# Details of Representations

Application ID	24042402
Proposal	14 level residential flat building containing 36 dwellings, all of which are to be offered as affordable housing (social housing)
Location	8 HOCKING PL ADELAIDE SA 5000

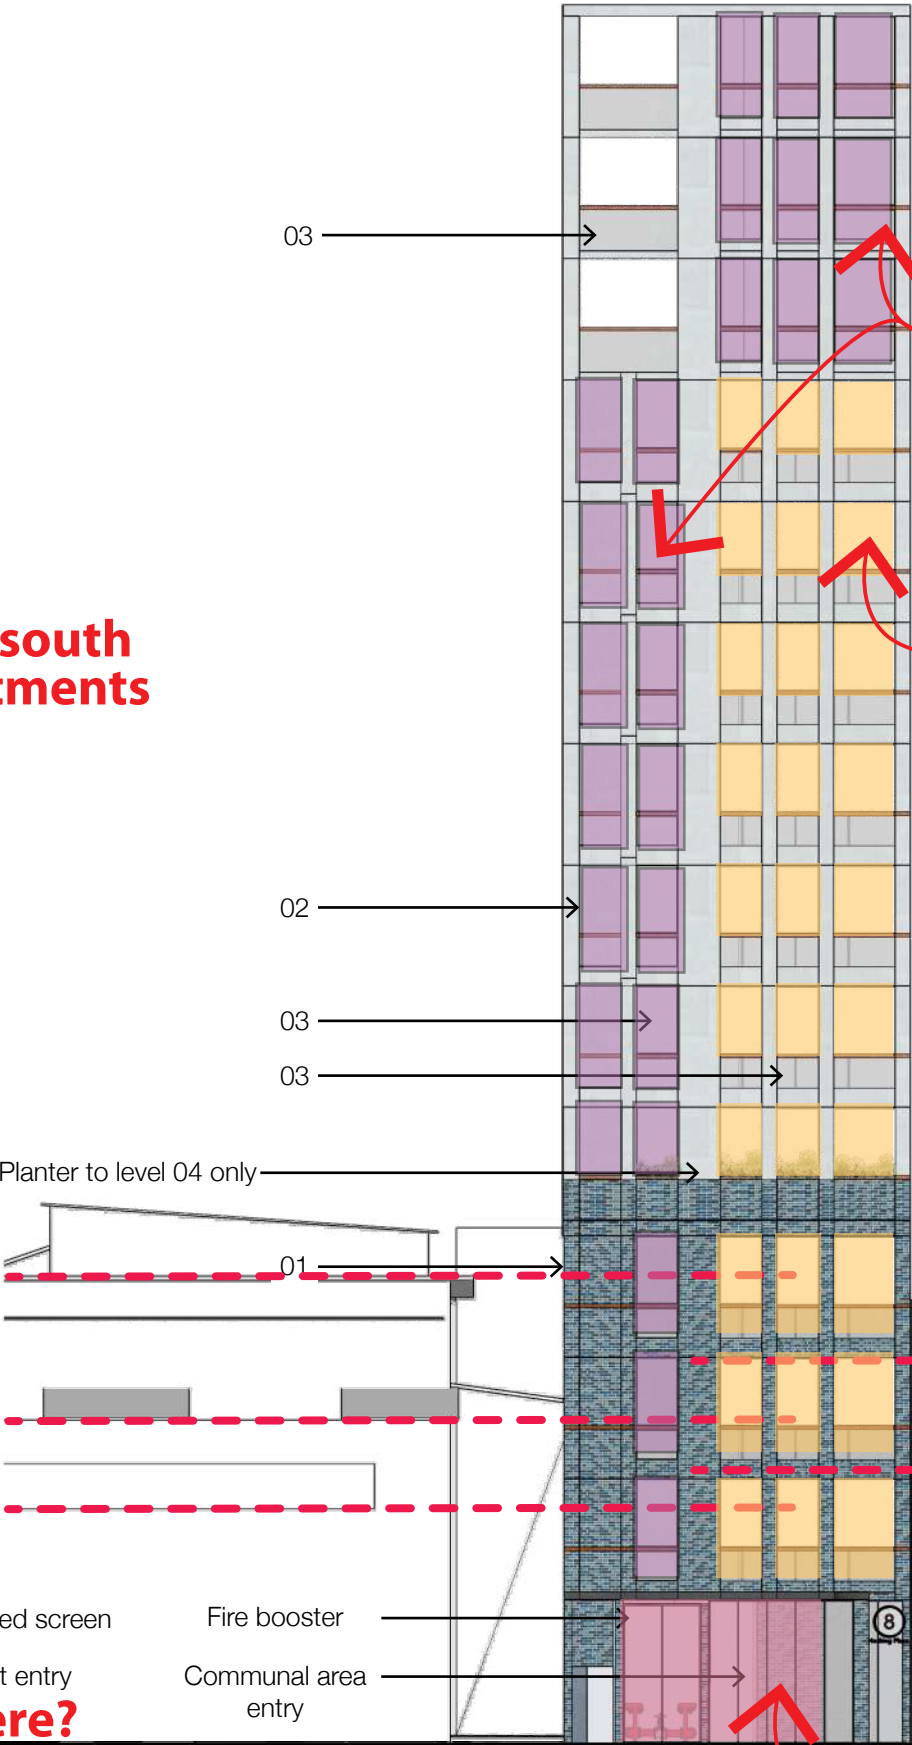
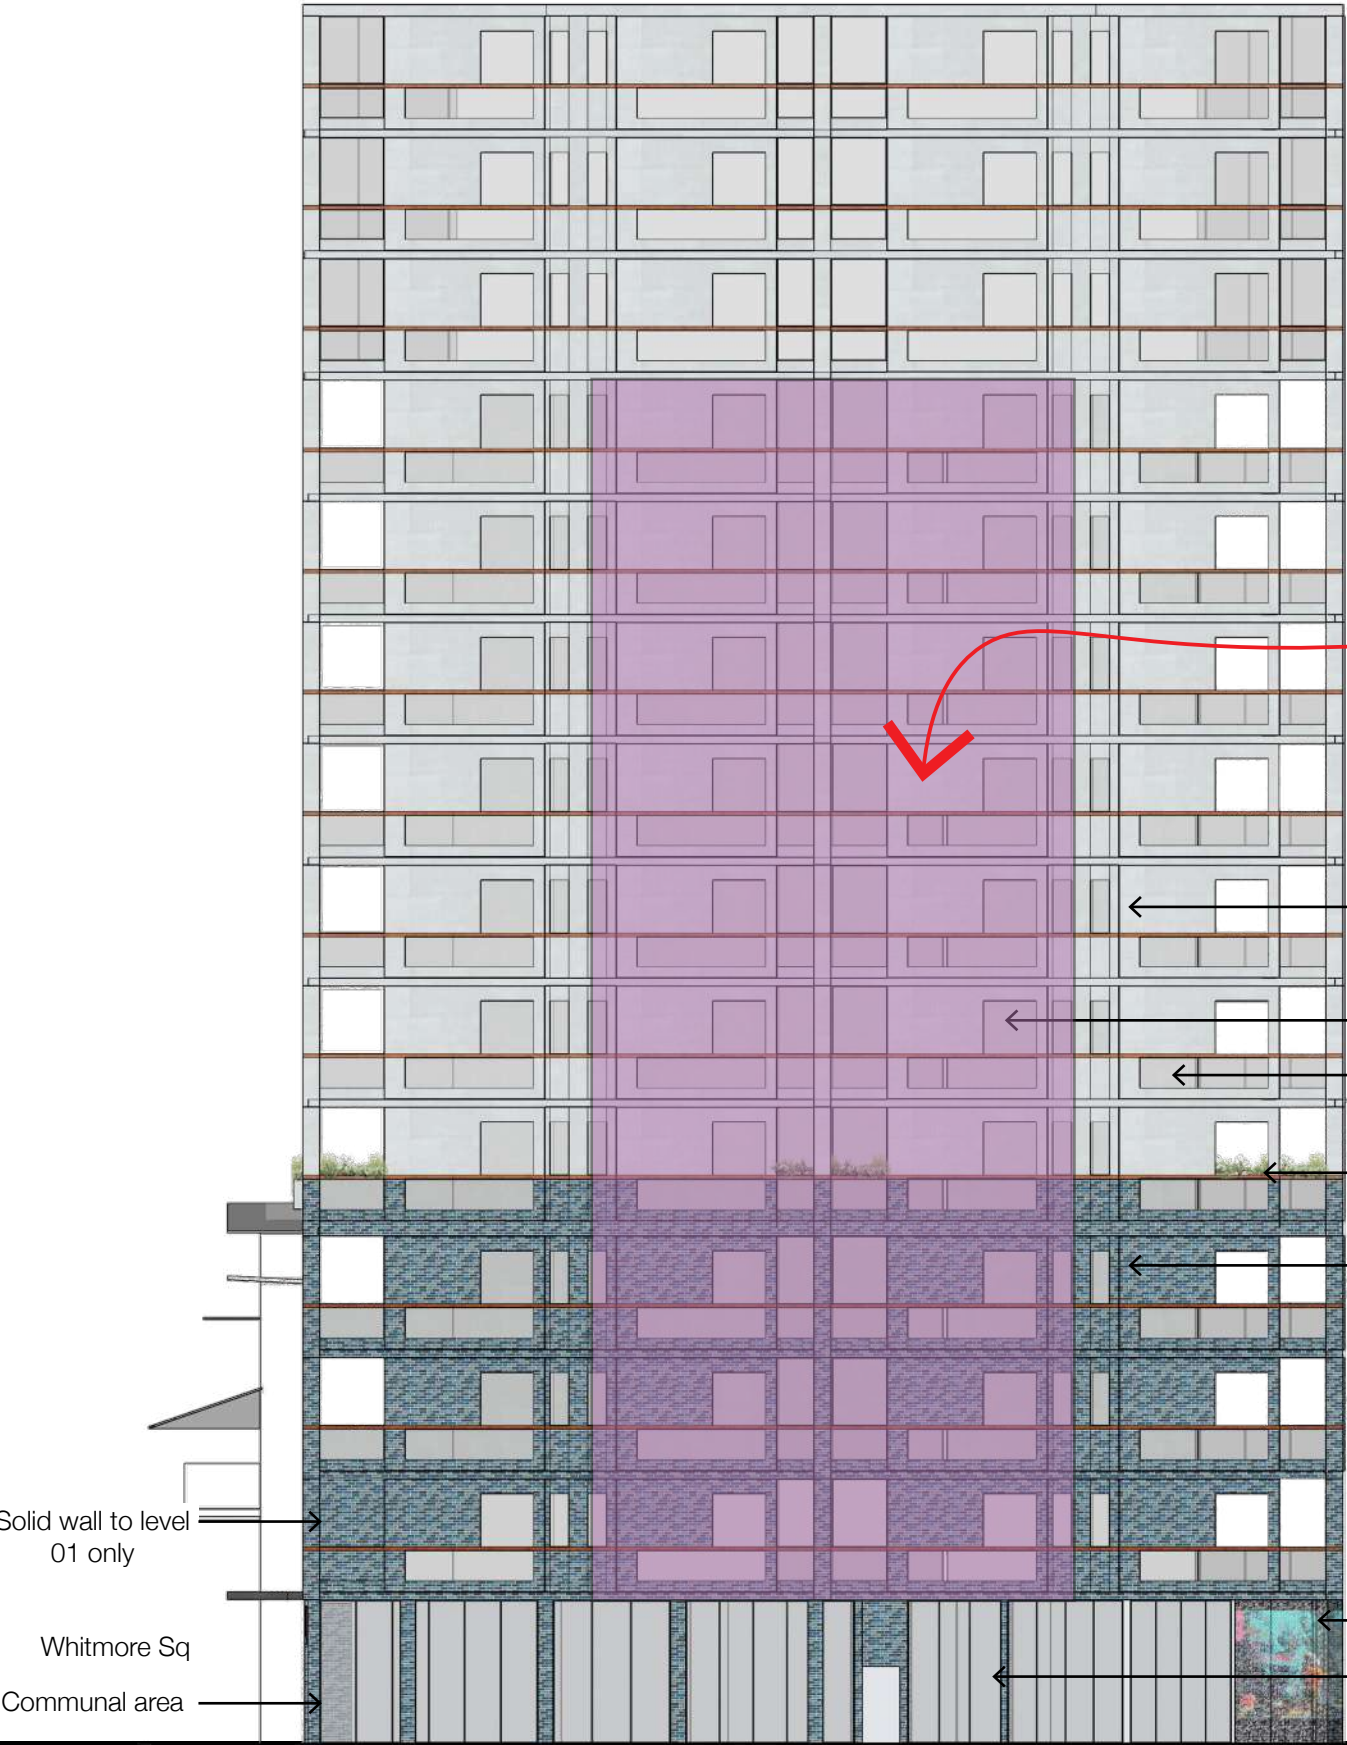
zero western sun shading

minimal western sun shading

ignored contextual height lines

where?  
no signalling/  
detailing

Elevations

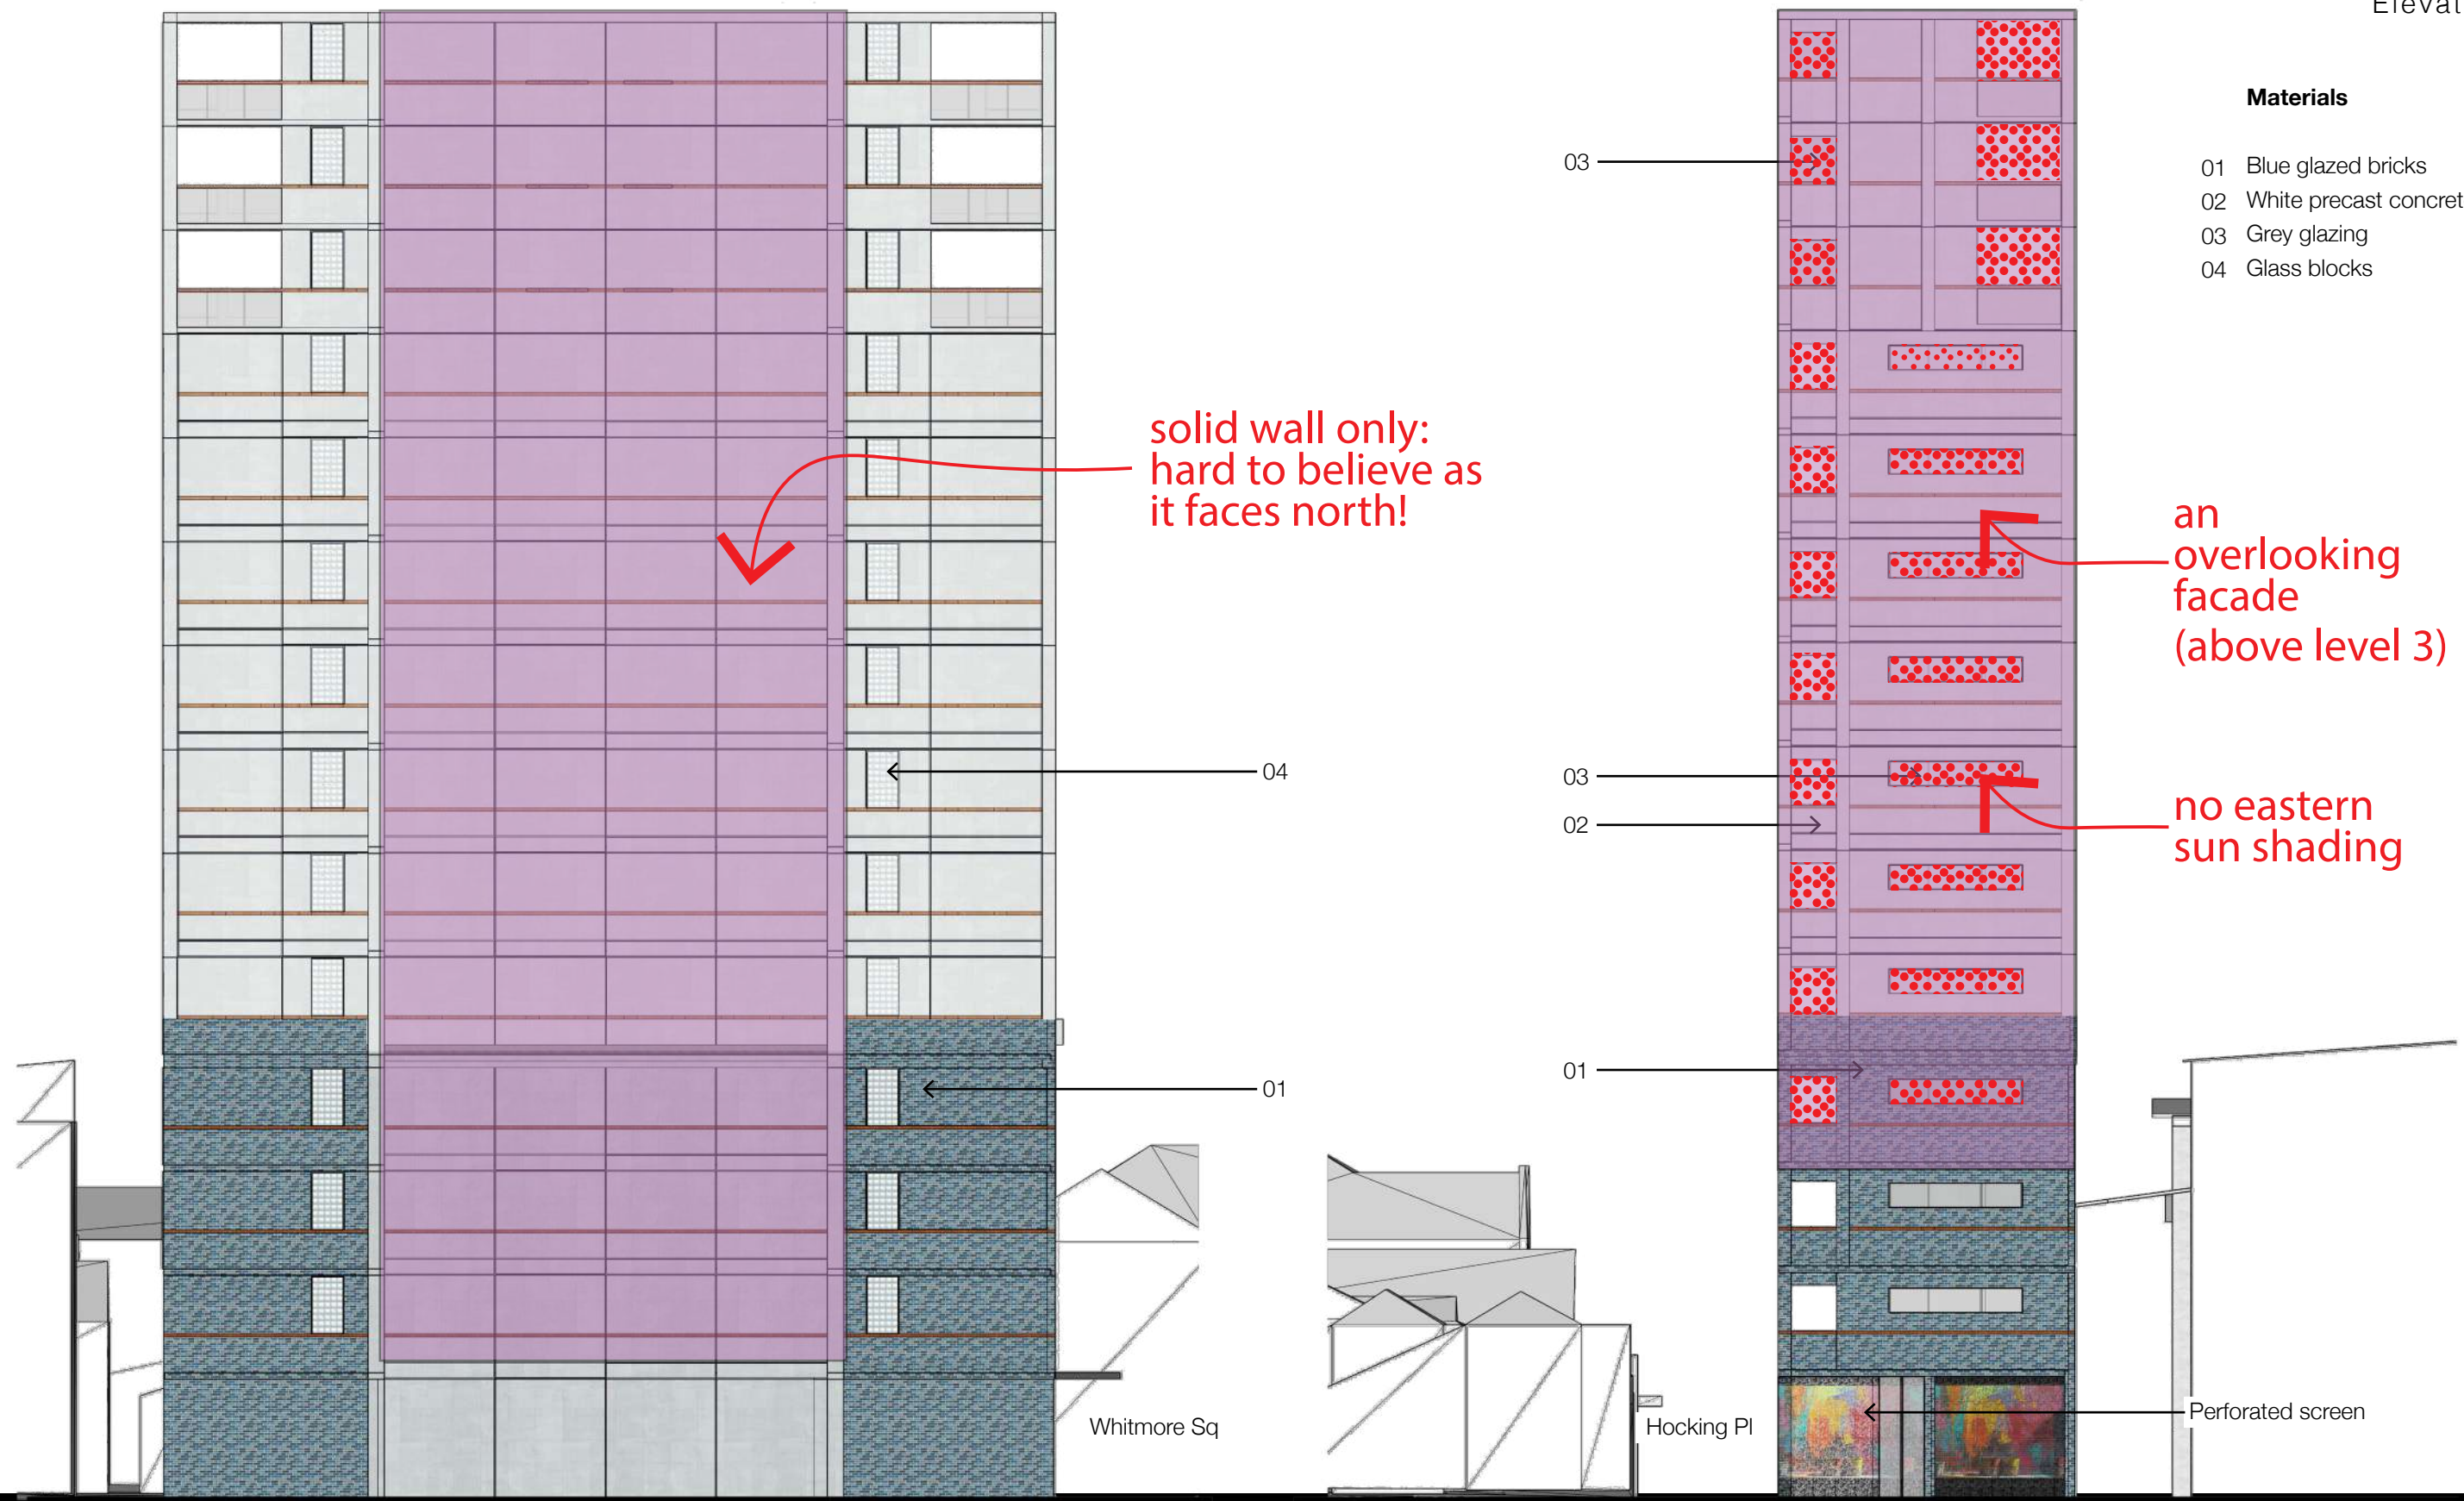
The proposed building form does not adopt measures called for by DPF 5.2. Most specifically, the building does not provide for additional set back, modulation and articulation of elevations (to avoid blank walls) for that portion above 29 m.

It is unclear from the schedule provided as to whether an applied finish is proposed to concrete panels. The use of blue glazed bricks for the first 4 floors is also questionable in a context where red brick prevails and certainly does not make for a podium.

Although noted on the roof plan, **no lift overrun is shown in section/ elevations/ model views/ heights calcs** > add 4.5m – 1m within the indicated parapet zone = nett +3.5m > 46.3 + 0.2 + 3.5 = **50m** overall in that zone. That's **72% over** the 29m height limit.

- **Nor are pv panels on inclined frames shown**, which will add another 1m above the ridge height for the whole roof run > 46.3 + 0.2 + 0.7 = 47.5m general overall max height.
- Other rooftop plant seems to have gone missing...
- Mechanical services;
  - o a probable requirement for the central airless/ lightless corridors.

FOR 47.5m BUILDING + 29m BUILDING

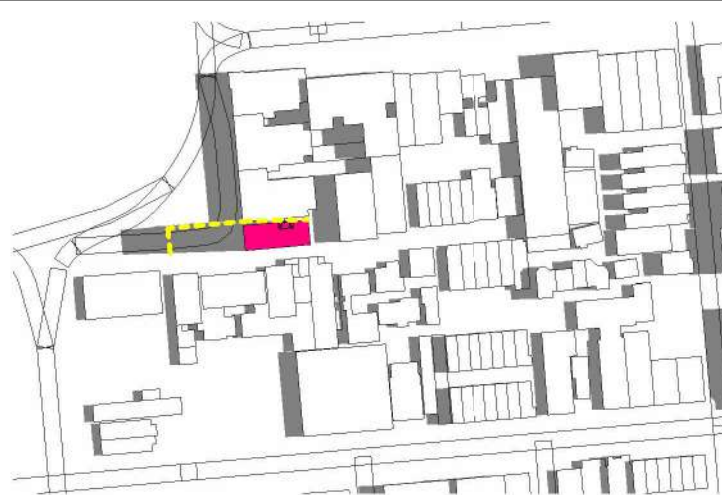
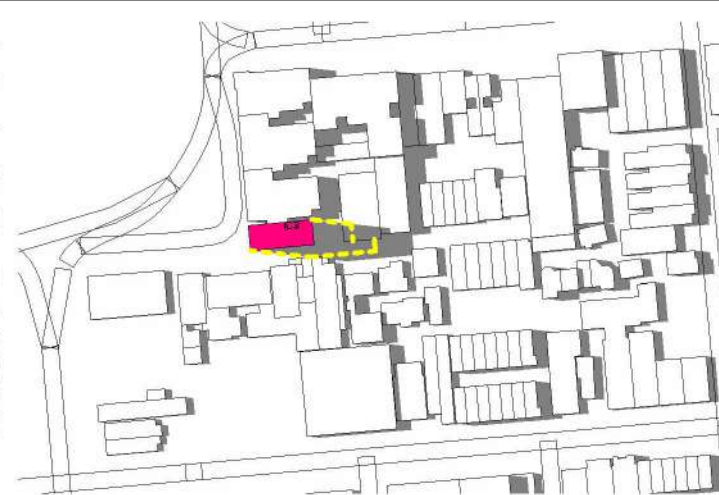
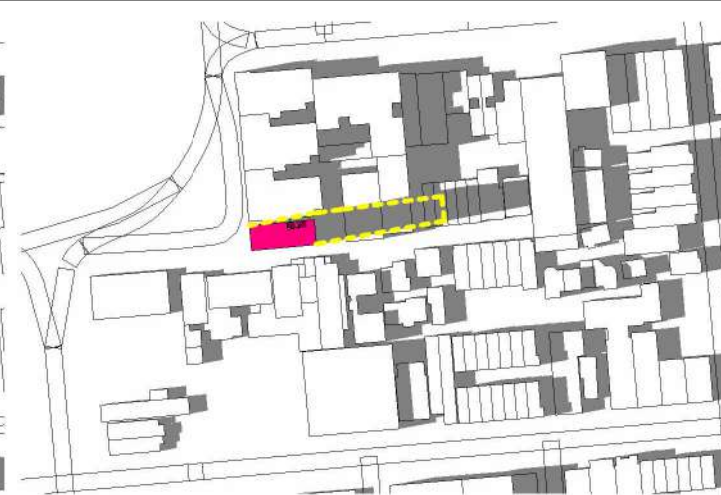
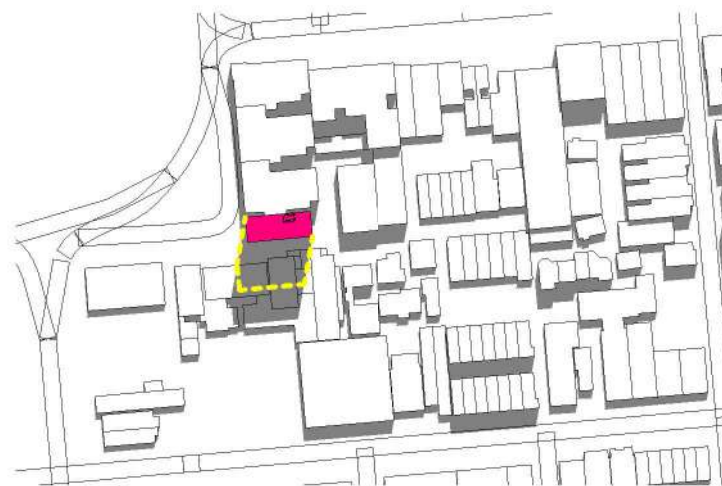
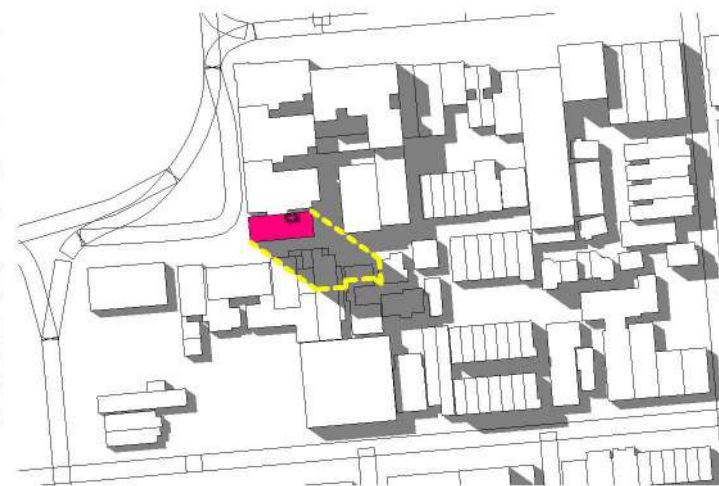
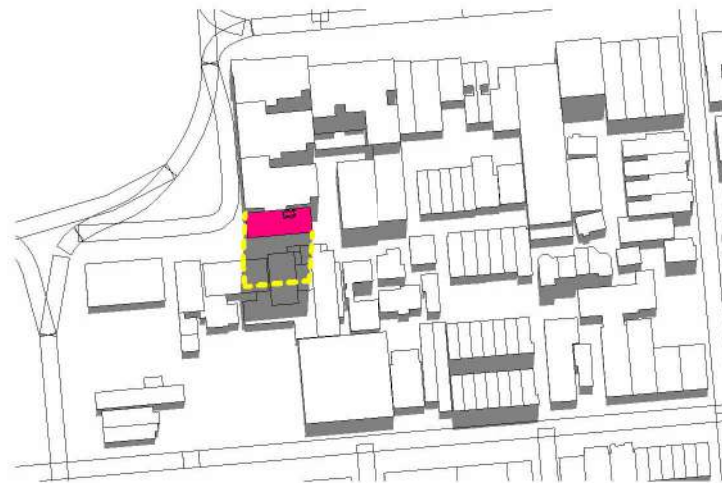
Being aghast at the rudeness of scale, overshadowing and adopted materiality in relation to these items. We have retained the eminent Adelaide Heritage Architect, Douglas Alexander to more professionally elaborate on our immediate response, to take us beyond 'its just the vibe'.
